11/17/99  
John Lohmeyer  
T10 Chairman

**Subject: Proposal for Fast-160 to be included in SPI-4**

Revision of this proposal incorporates changes based upon the November SPI-4 working group meeting. The enclosed proposal addresses Fast-160 and introduces the concept (PPR code) for Fast-120 as an intermediate negotiation. Specifics are given for Fast-160. Specifics for Fast-120 are left as an action item after agreement on the specifics of Fast-160. It is assumed that Fast-120 is a scaling of Fast-160. Additional intermediate steps are not proposed due to the issues of providing additional clocks and/or additional compensation delays.

**Figure 44 - LVD timing measurement points for DT = Fast-160 data transfers**

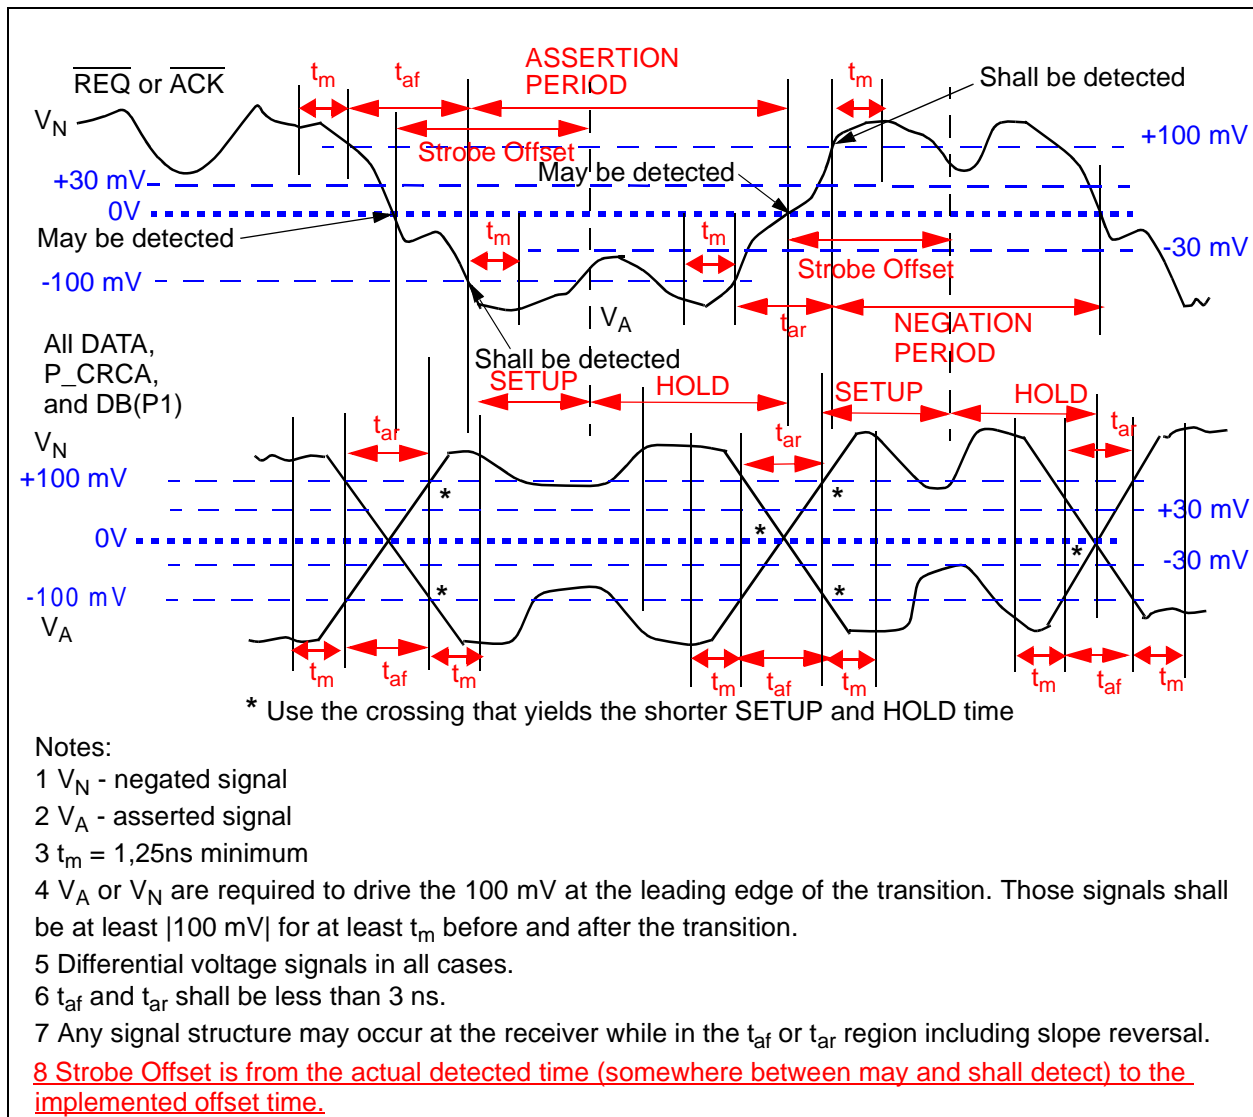
The signal shall transition from -100 to +100 mV or +100 to -100 mV in 0 to 3 ns, the waveform between -100 and +100 mV is not otherwise specified. Signals shall remain above the  $|100\text{ mV}|$  level for 1,25 ns at each end of the transition. The signals shall not drop below  $|30\text{ mV}|$  except during the transitions. Conditions exist with longer, loaded SCSI busses and irregular REQ and ACK pulse widths where long assertions or negations produce a much larger signal than short assertions or negations. This sets up an environment where the short REQ or ACK pulses may not have adequate timing margin unless the definitions in figure 44 and figure 43 are used in the measurement of timing parameters.

Figure 46 - System setup and hold timings for DT data transfers (all times in ns) (TBD)

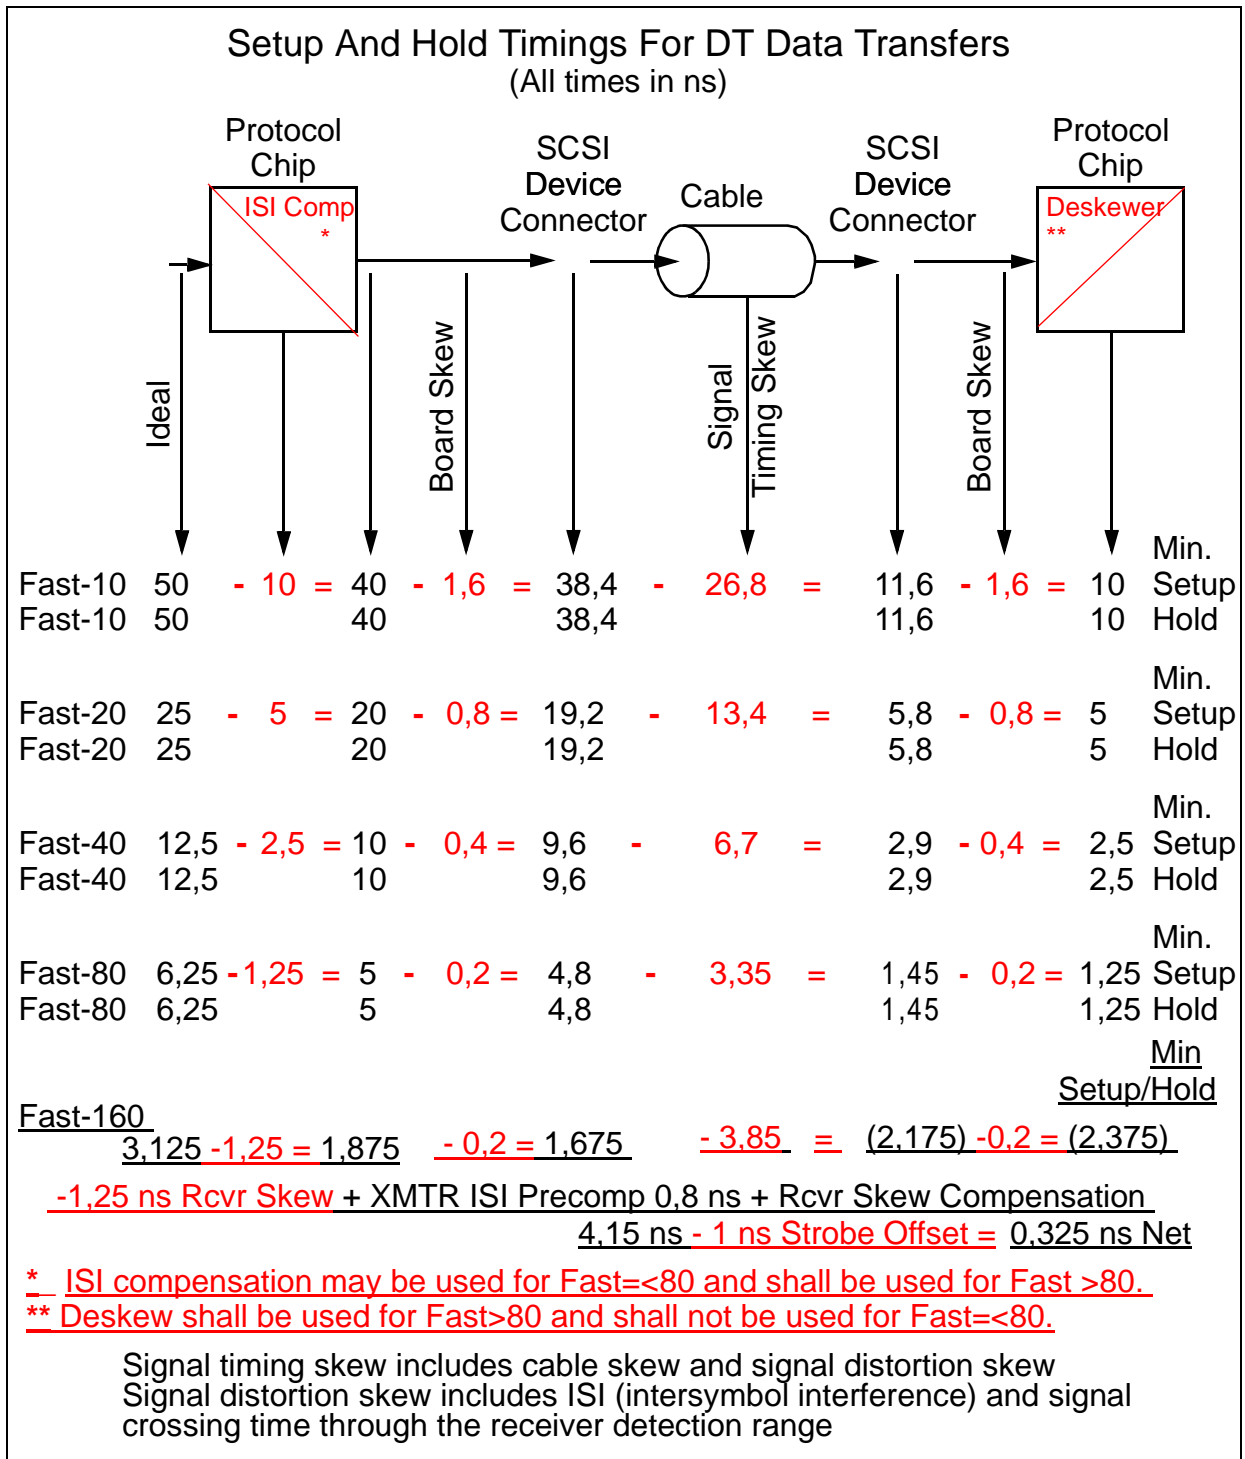
The key elements of the proposal are similar to descriptions made in recent T10 presentations with the intent of packaging the elements of Fast-160 in a single package as T10 agreements are reached pending an initial SPI-4 draft with Fast-160 included. Discussion at the November meeting focused on Table 32. After Table 32 stops changing, based upon modeling and test results, a decision should be made regarding the combination of Tables 30, 31, and 32 (one, two, or three tables). Also after Table 32 stops changing the other table(s) and Figure 46 will be made consistent with the results of Table 32.

Figure 46 shows how the setup and hold times are calculated for various physical configurations on SCSI devices that support DT data transfers. The minimum set up and hold timings specified in figure 46 shall be used. Note that these values are different for the driver and the receiver but that the receiver sensitivity provides the threshold points for both. This is required because both extreme cases of attenuation need to be covered:

Figure 47 - Fast-160 Training Pattern

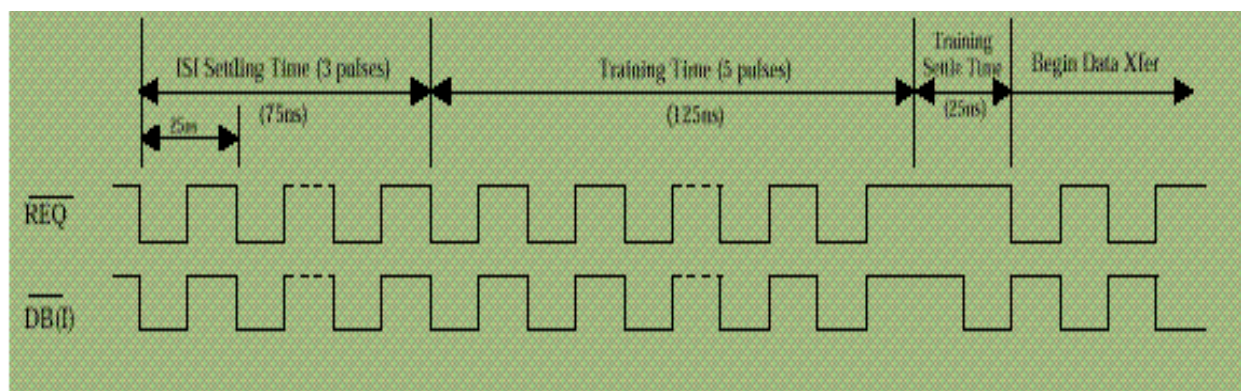
The training pattern for Fast-160 shall be transferred at the start of each Fast-160 data phase. Return ACK/REQ signals from the receiving SCSI device shall be ignored by the originating SCSI device during the training pattern. The training pattern for Fast-160 shall conform to Figure TBD. The receiving SCSI device shall use some or all elements of the training pattern to achieve deskewing. The transmitting device shall not make an intentional shift in relative timing between the databus and the ACK/REQ signal subsequent to the training pattern during the DT data phase. The requirement to not intentionally change relative timing does not include the effects of ISI or ISI compensation.

Figure N.1 illustrates a transmitter drive strength technique.

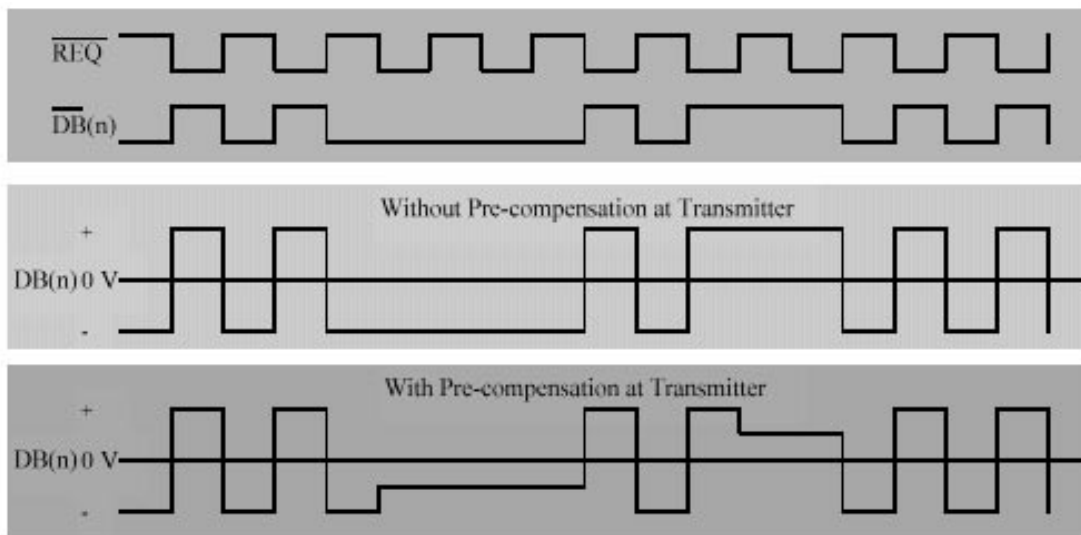
ISI compensation may be achieved by several techniques including time shifting and transmitter drive strength switching. The technique employed is vendor specific but SPI-4 requires that the technique achieves at least a 0,8 ns reduction in ISI at Fast-160.

**Figure N.2 Example Deskewing Technique**

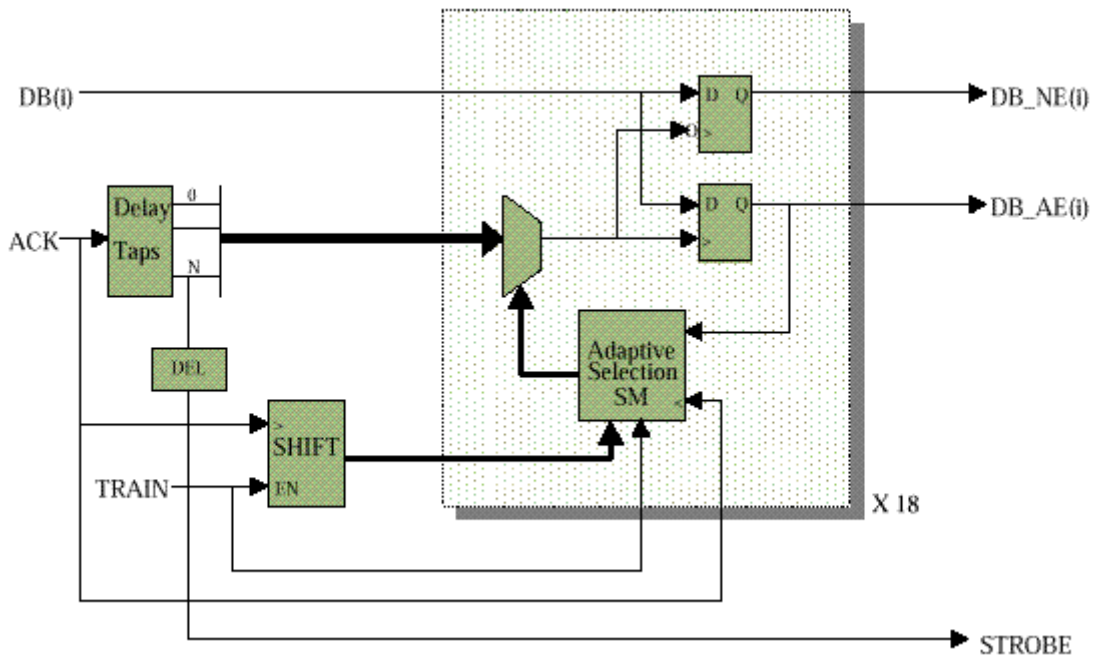
The deskewing technique used in the receiving SCSI device is vendor unique. Any technique that works with the SPI-4 specified training pattern and complies with the specified Receive Skew Compensation timing requirement is allowed. Figure N.2 illustrates such a technique. The training pattern is not available in Fast= $\leq$ 80 and consequently deskewing is only used for Fast $>$ 80.

In this example the tap selection is based upon a binary search algorithm.
